BUILDING PLAN
FOR
TOTAL BODY THERAPY & WELLNESS
260 PINE STATE STREET
LILLINGTON, NORTH CAROLINA

TOWN OF LILLINGTON

RE: TOTAL BODY WELLNESS AND THERAPY

Please see the below response to comments for the above-referenced project.

FLOOR PLAN
1/4" = 1'-0"

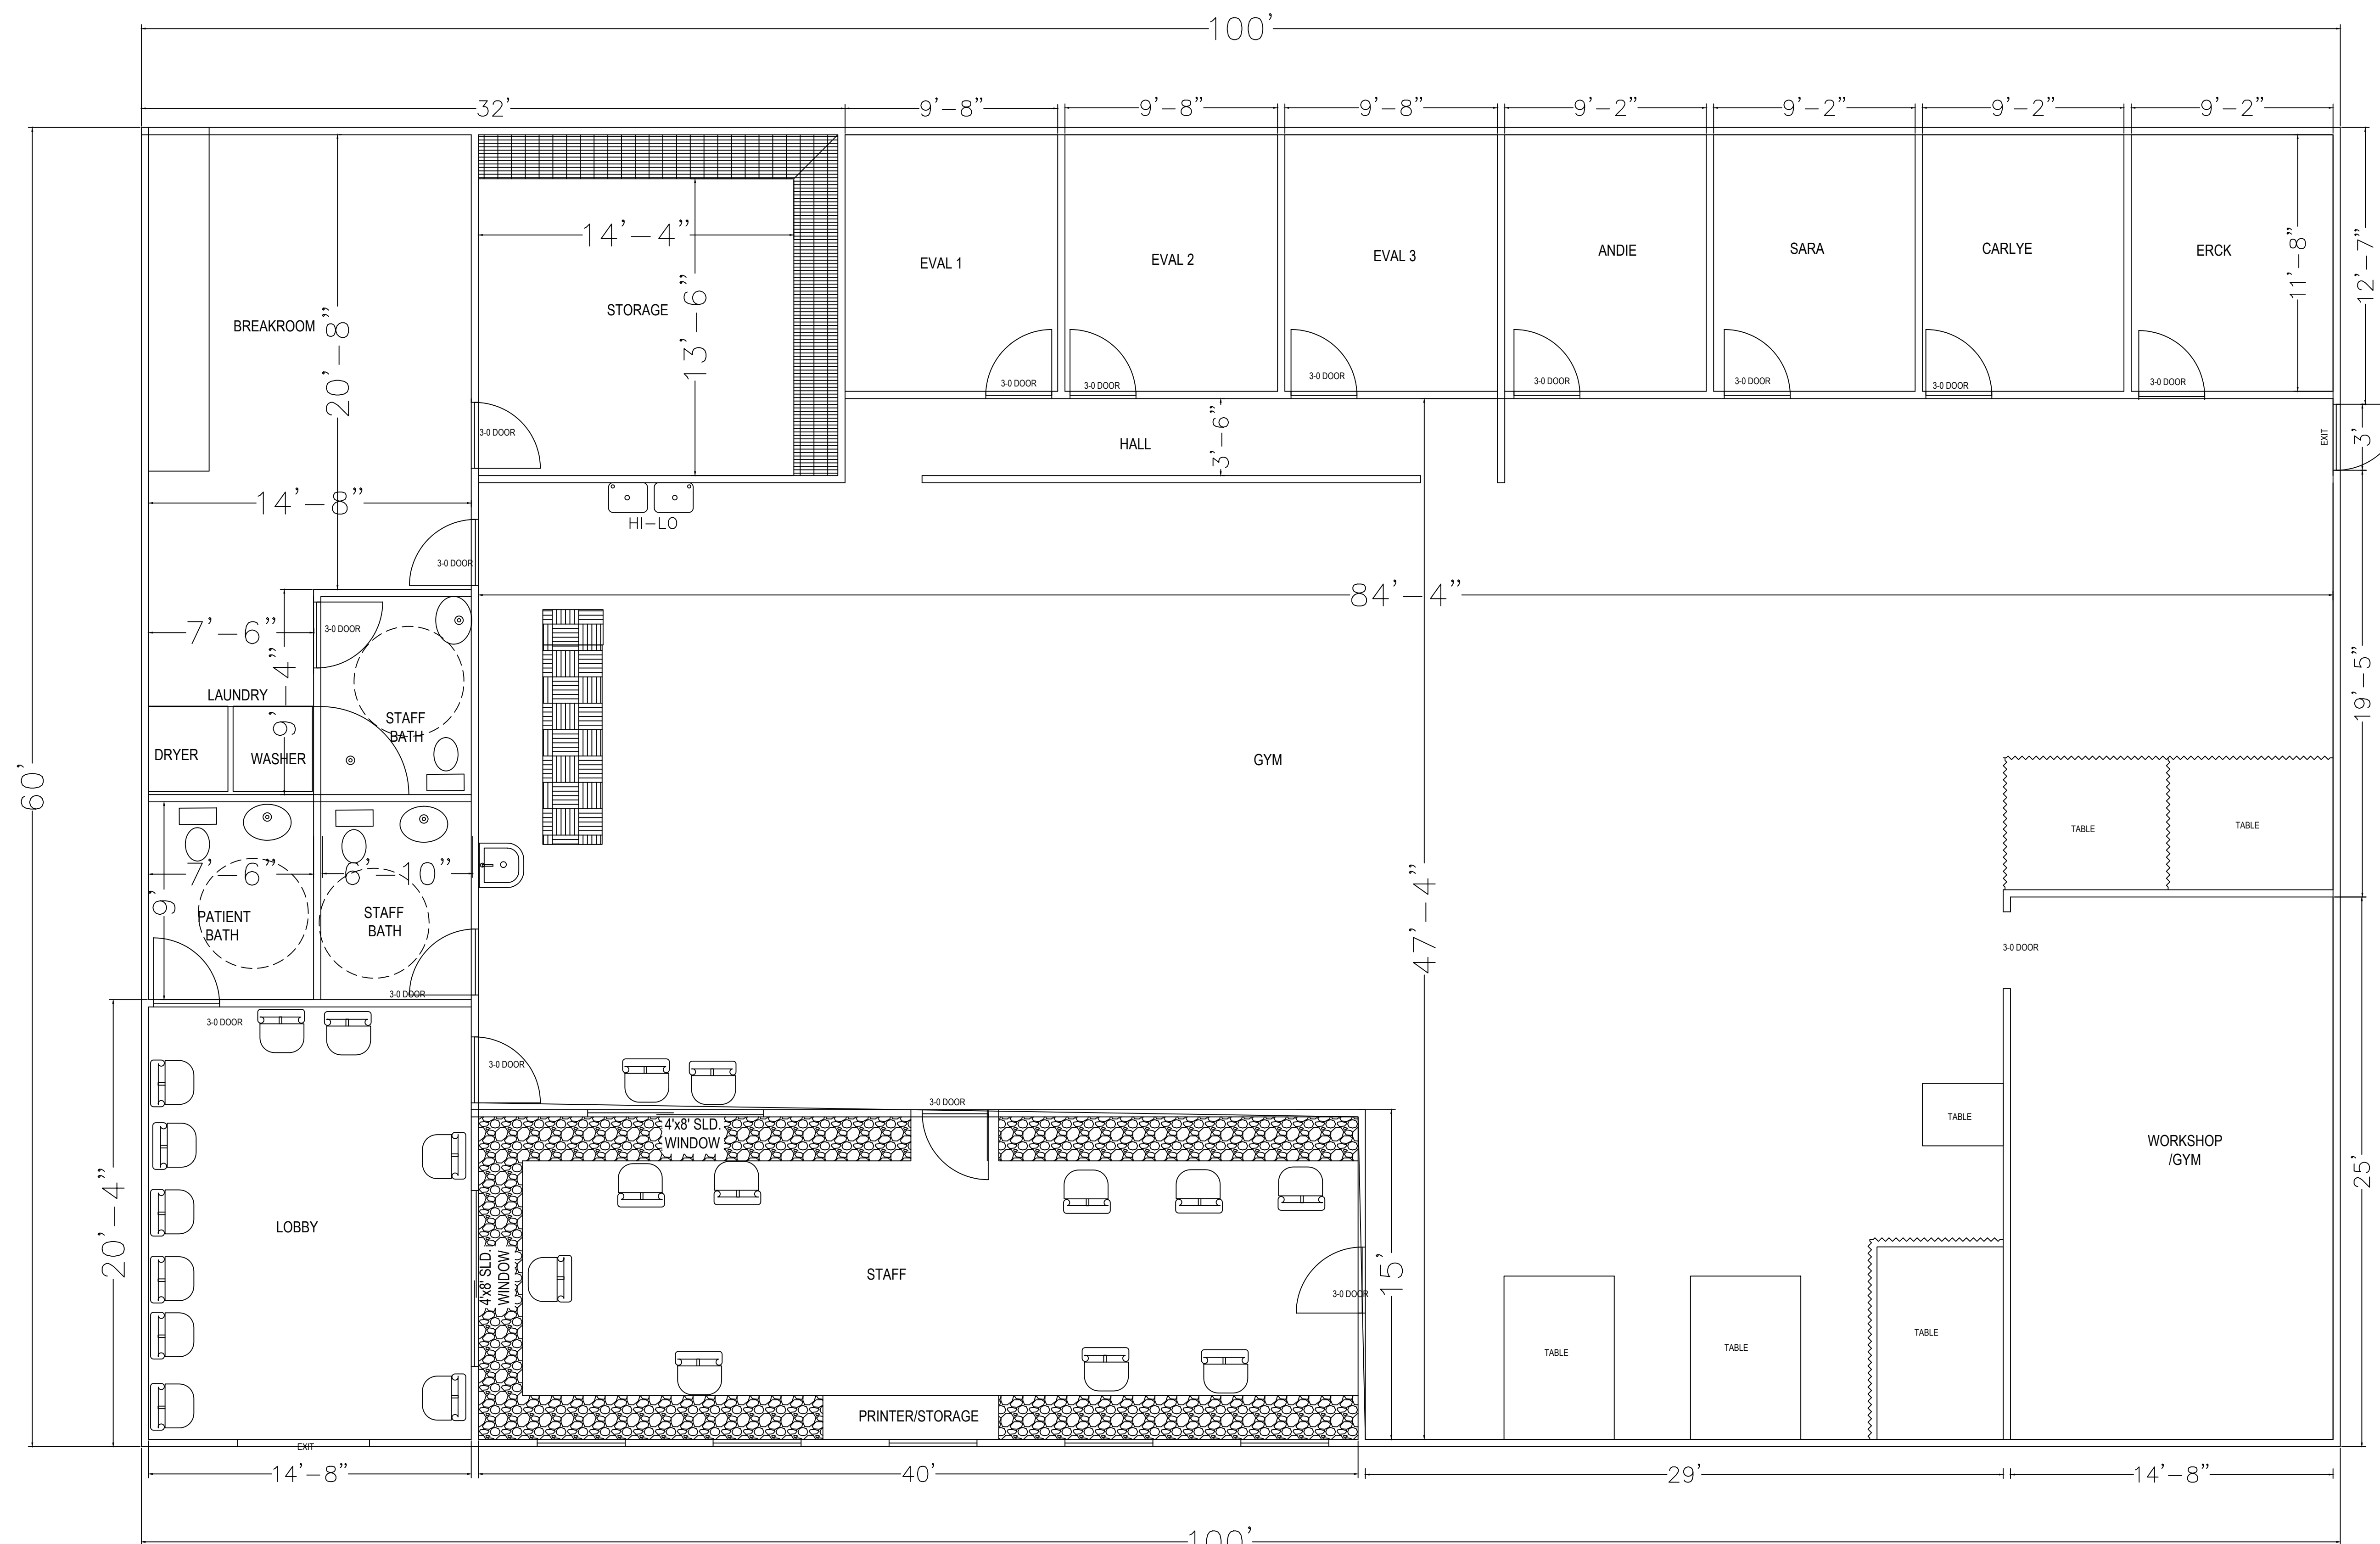
- Occupant load not calculated correctly. **Occupant load is corrected.**
- Need detail for slab insulation. **Slab insulation shown on footers in foundation.**

LOCATION	TYPE	AREA	OCCUPANCY	OCCUPANCY
EMPLOYEE	BUSINESS	4000 SQ FT	100 SQ FT pp	40
INDOOR SEATING AREA	BUSINESS	1800 SQ FT	100 SQ FT pp	18
STORAGE (EMPLOYEE)	BUSINESS	140 SQ FT	100 SQ FT pp	2
TOTAL				60

PLUMBING
1/8" = 1'-0"

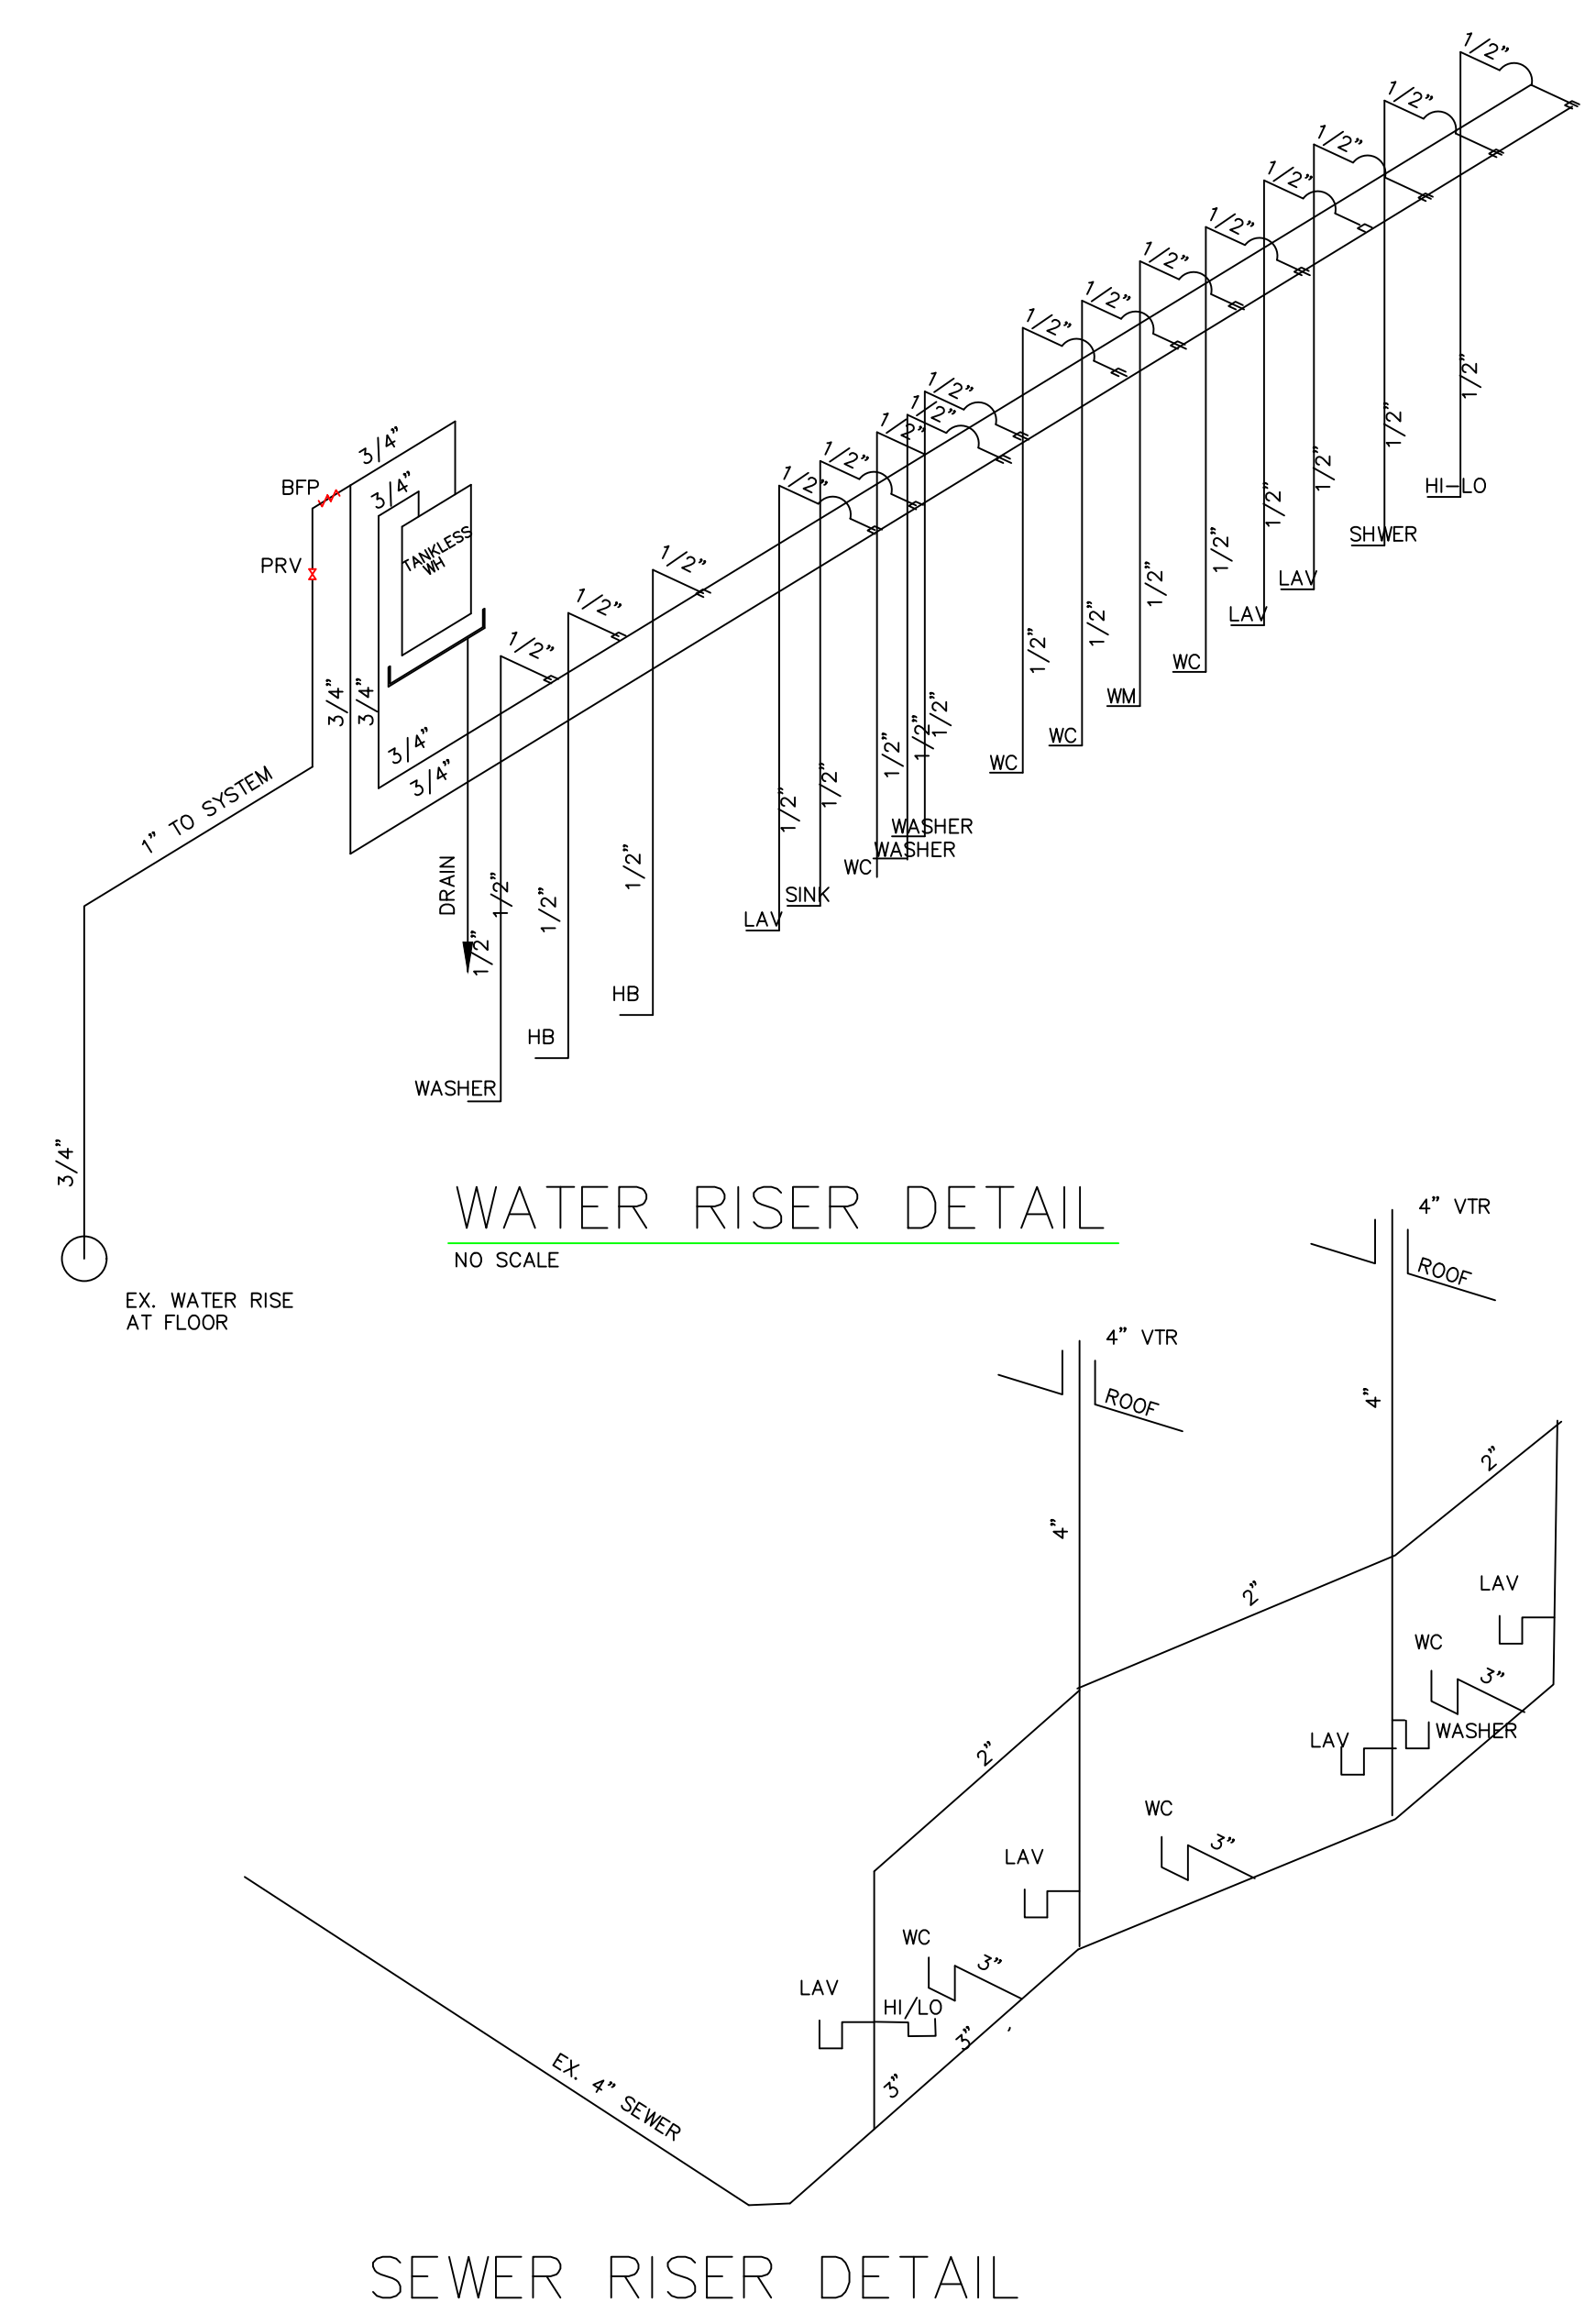
- Plumbing plan shows no high low on riser plan. **Riser shows hi-lo on Plumbing Plan.**
- No laundry on diagram. **Laundry added on all sheets including risers.**

MECHANICAL
 1/8" = 1'-0"

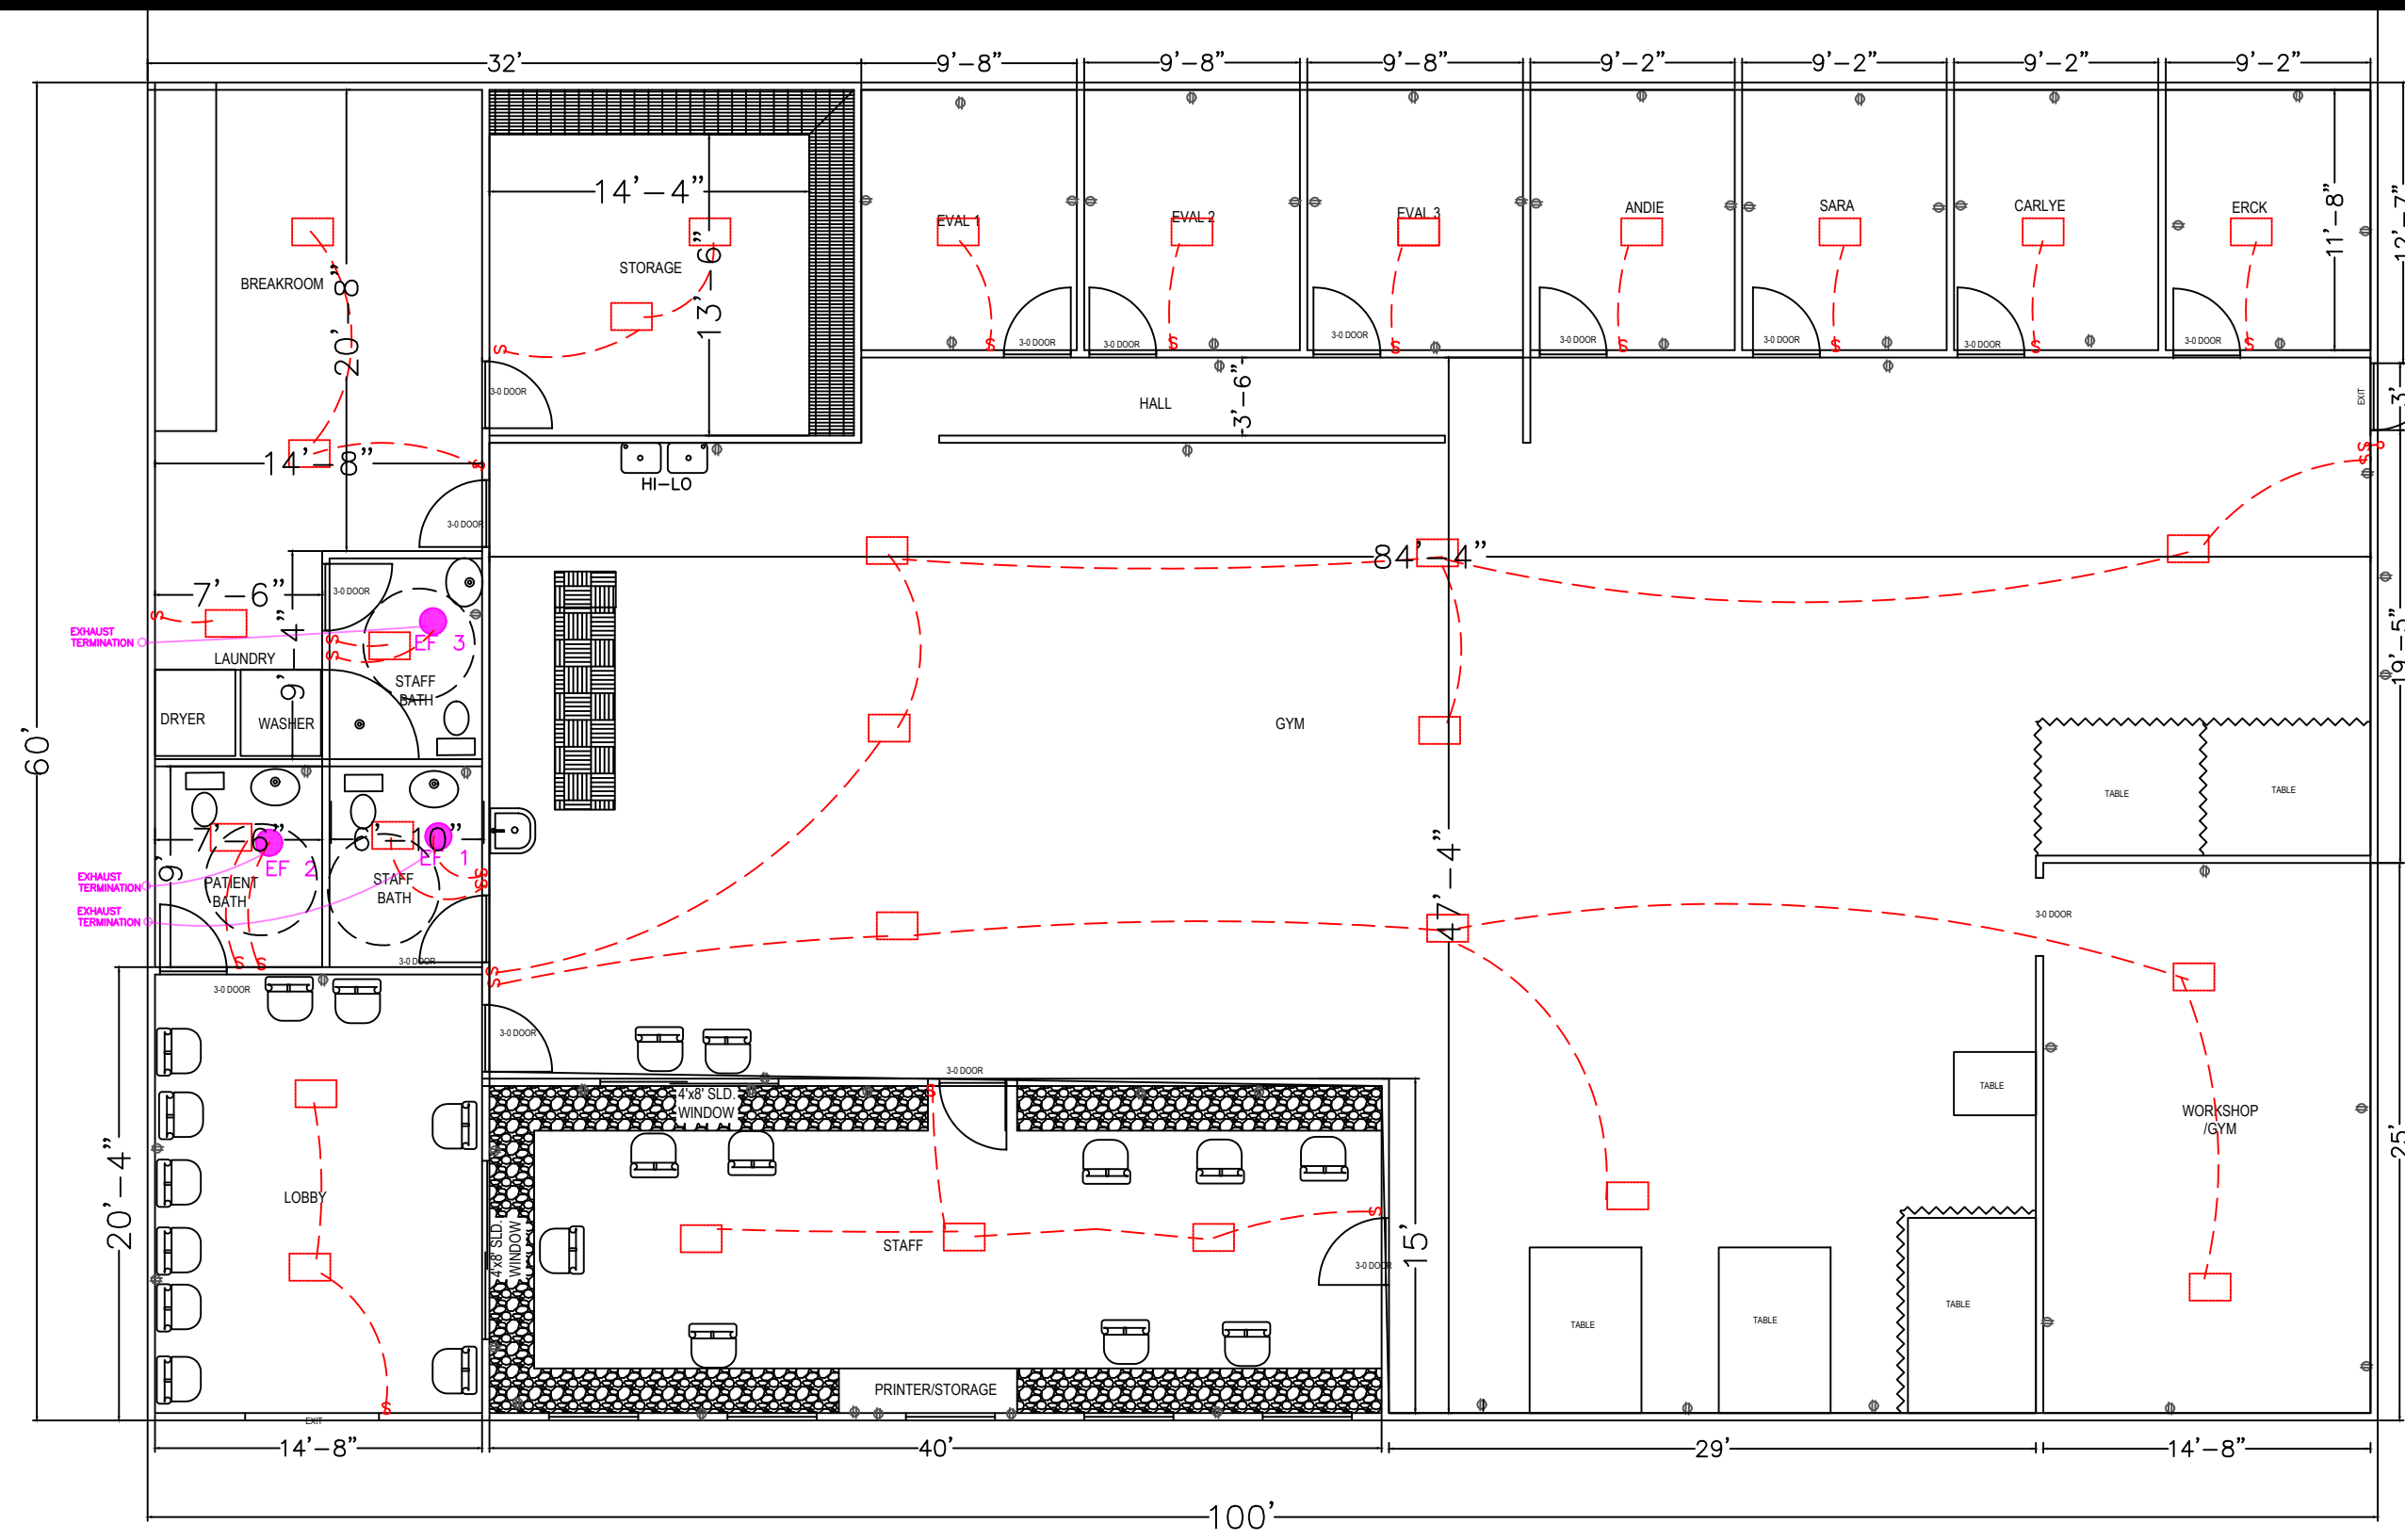
- Return air size? **Returns (5) are 18"x24" as shown on HVAC Pan.**
- Dryer Duct location? **Dryer duct shown on HVAC Plan.**
- Exhaust Fans? Where do they terminate. **Terminations are shown on plans.**

- Does not appear system will be balanced with two air returns. **The system has 5 Returns which balances.**
- Smoke detectors in HVAC? **Dryer duct added to HVAC**
